Groundwater Transfer Review Summary Form

Transfer/PA # T- 14245

Application: T-14245

Applicant Name: Oster Farms

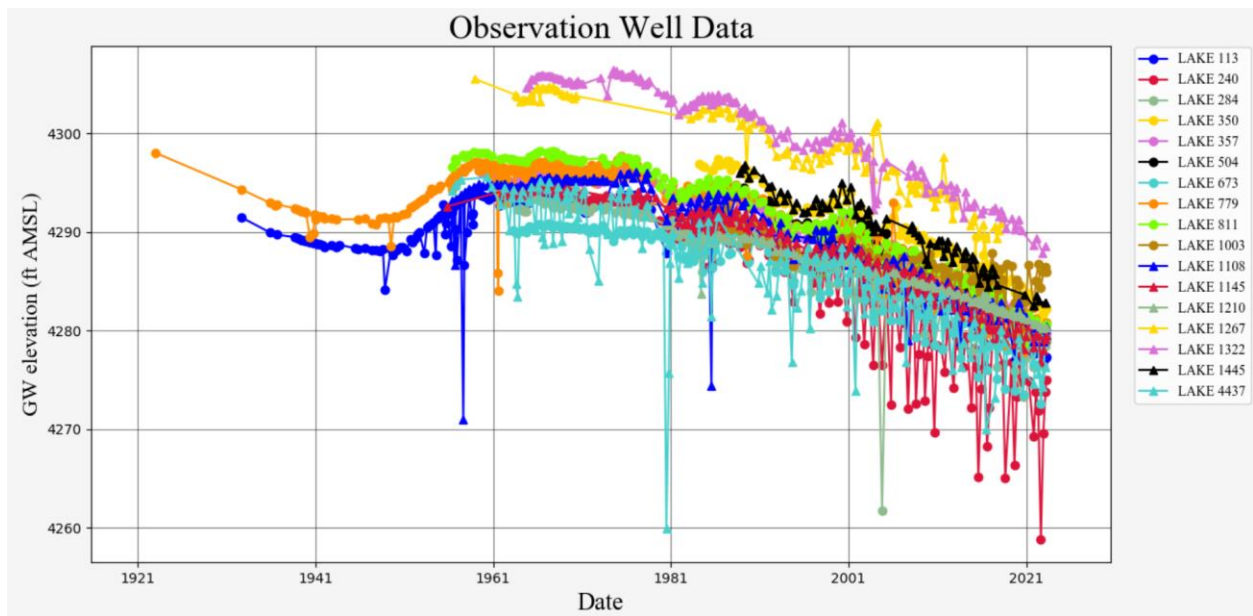
Groundwater in the Fort Rock Valley-Christmas Valley area (Fort Rock Classified Area) is identified as a single groundwater system. Groundwater is found in both a shallower predominantly basin-fill sediment unit and a deeper predominantly volcanic rocks and sediments unit below. The predominantly basin fill sediment unit and the predominantly volcanic rocks and sediment unit both readily yield groundwater, and the two units are hydraulically connected.

Miller (1986) describes the groundwater source as the main groundwater reservoir. That reservoir includes groundwater in different geologic units. The reservoir has three characteristics. First, the "natural" groundwater level changes less than 1.5 feet annually, indicating the system is highly modulated. Second, the 1980s potentiometric surface was approximately 4292 feet elevation amsl basin-wide with Silver Lake an exception. Third, the reservoir consists of numerous water producing zones in several formations, all having an essentially common potentiometric level, and all being very transmissive in general.

The authorized well produces groundwater from water bearing zones within the main groundwater reservoir. The proposed well will also produce groundwater from water bearing zones within the main groundwater reservoir.
